HUNTERDON COUNTY PLANNING BOARD

March 8, 2023

**RE: HCPB File numbers referenced below
Clinton Commons
Block 14 Lot 32
TOWN OF CLINTON**

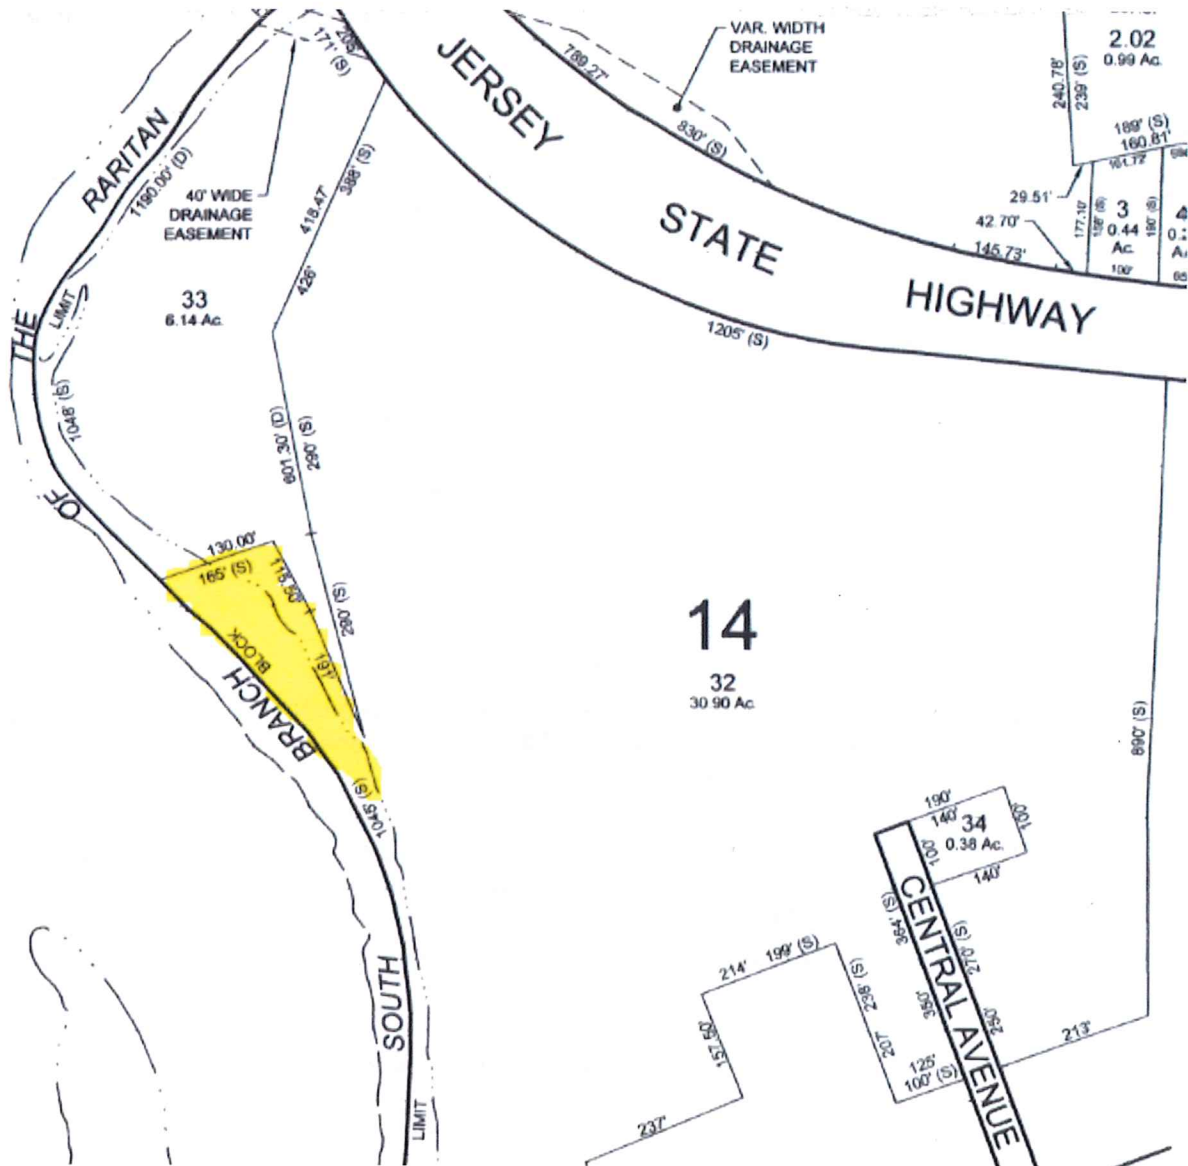
2.2 The 2012 tax map for the Town of Clinton, includes an area of lot 32 that is not included in the CAD file or in the subdivision and site plan. The area in question is highlighted in the images below. Is this area being subdivided off? The County has no record of a subdivision application.
